PERMIT 03-332292

SEWAGE DISPOSAL SYSTEM
HOWARD COUNTY HEALTH DEPARTMENT
BUREAU OF ENVIRONMENTAL HEALTH
410-313-2640

SUBDIVISION Brantwood II LOT NUMBER 16 ADDRESS 3108 Argent Path

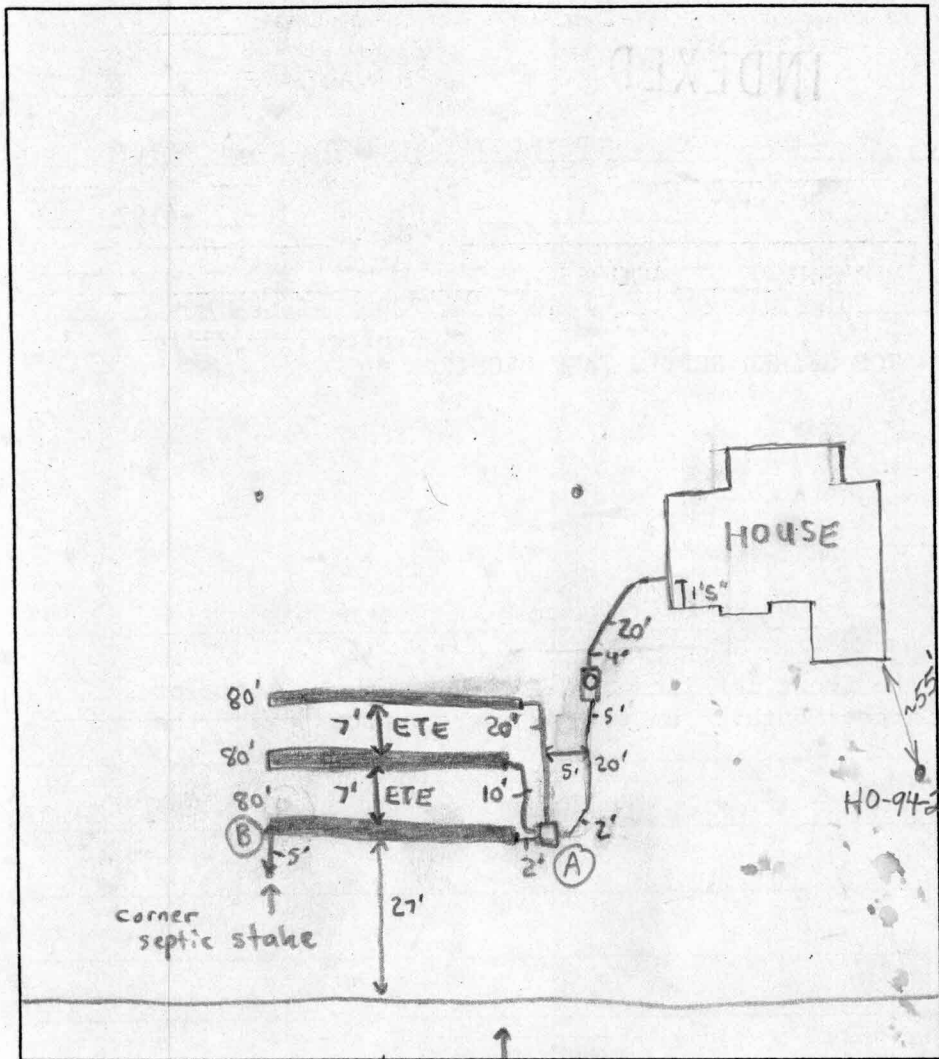
PRE-CONSTRUCTION INSPECTION: Argent Path 4/16/01 System to be installed as per BP plan. Septic tank to be outside of well radius. (BB)

INSPECTION COMMENTS: 4/18/01 - CONTOUR ALTERED DUE TO (1-2') OF FILL & GRADING - SO INSTALL DBOX IN LOCATION (A) AND RUN 3-80' TRENCHES TOWARDS LEFT LOT LINE, (INLET ON AT 4' BOTTOM AT 6') TOWARDS (B) (SRW) 4/20/01 - SYSTEM COMPLETE PENDING HOUSE CONN (SRW)

5/8/01 FINAL INSP - OC TO COVER ALL WORK, HOUSE CONNECTION CONFIRMED. DIC
